Geotechnical Investigation

Proposed Residential Building

197-201 Wilbrod Street
Ottawa, Ontario

Report PG5955-1 Revision 2 dated January 26, 2023

DRAWING PG5955-1 – TEST HOLE LOCATION PLAN

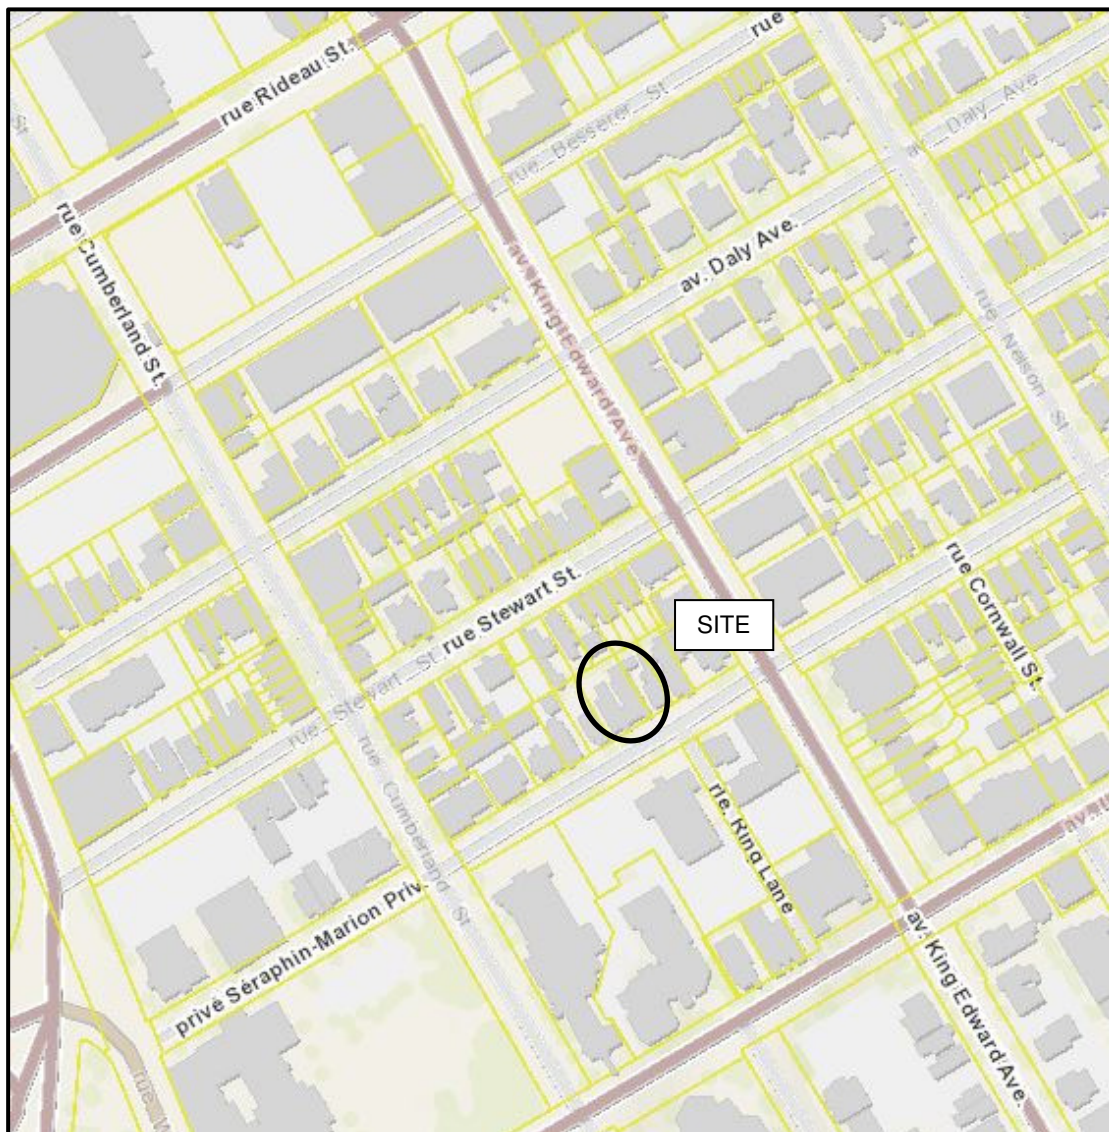
Geotechnical Comment 1: *Test hole location Plan is missing in the appendix 2. Please note that at least 1 borehole is required in the building area.*

Geotechnical Comment 1: *As per Geotechnical Investigation and Reporting Guidelines for Development Applications in the City of Ottawa, a Borehole is required within the building area. Please note that the requirement of a revised Geotechnical report with a borehole investigation within the proposed building area will be added as a condition of Site plan approval.*

Response: The geotechnical investigation report has been resubmitted with the test hole location plan. Test hole locations were distributed in a manner to provide general coverage of the site, taking into consideration underground utilities and current site features (i.e. existing buildings).

Response: Paterson completed two boreholes within the area of the proposed building. Test hole locations were distributed in a manner to provide general coverage of the site, taking into consideration underground utilities and current site features (i.e. existing buildings). In view of the development size, the consistency in the borehole findings, and our knowledge of the area, the existing coverage is considered acceptable for the proposed building, from a geotechnical perspective.
